Service Bulletin

BULLETIN # 272

WELDMATIC 250I

INPUT CABLE TOROID REPOSITIONING

Figure 1 - Left/Right mounted INCORRECT

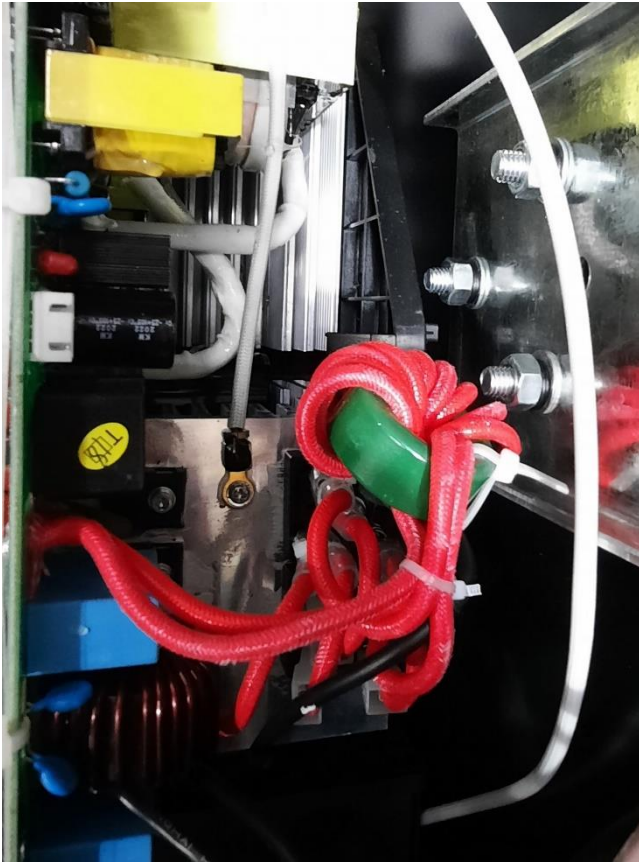
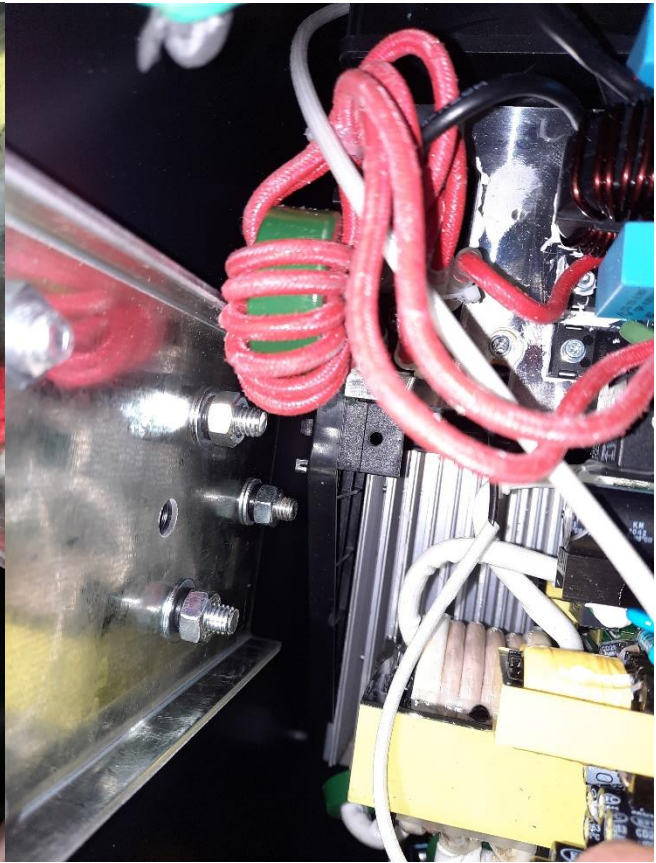
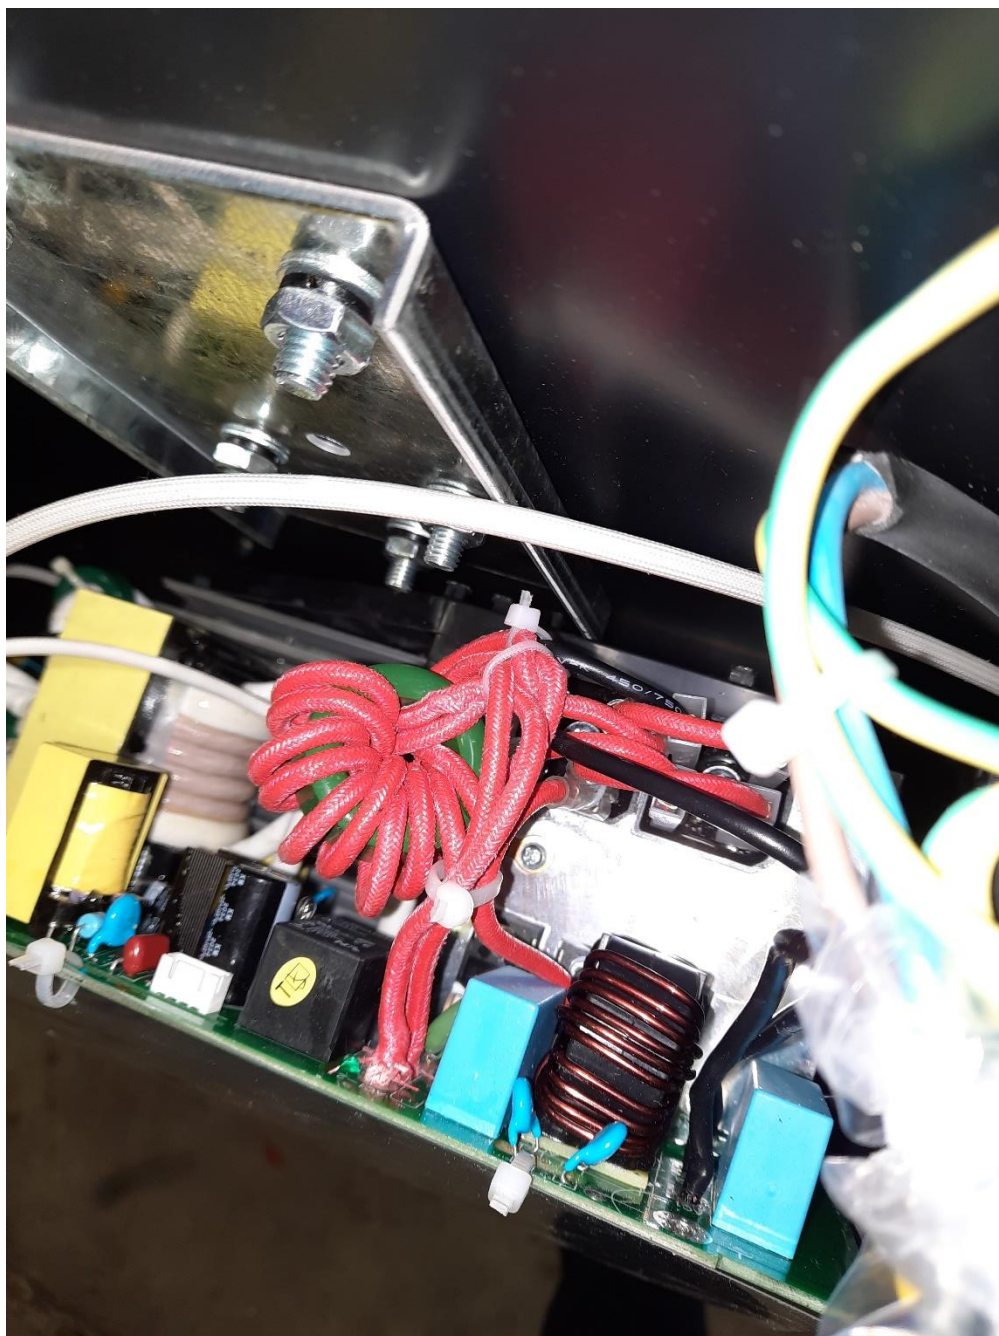
The input toroid shown in Figures 1 and 2 have been positioned incorrectly. The potential for the input cables on the toroid to chafe against the chassis of the machine is high and it should be repositioned.

Figure 1 shows the toroid mounted left/right – **this is incorrect.**

Figure 2 shows the toroid mounted forward/rear on the inside of the rectifier connectors – **this is incorrect.**

The input toroid is to be repositioned and secured to remove any potential chafing hazard.

Figure 3 shows the toroid mounted forward/rear, in the **correct** position.

Correct mounting can be seen in Figure 3 (page 3). Care should be taken not to reposition the toroid to cause further chafing on the heatsink below the new mounting position.
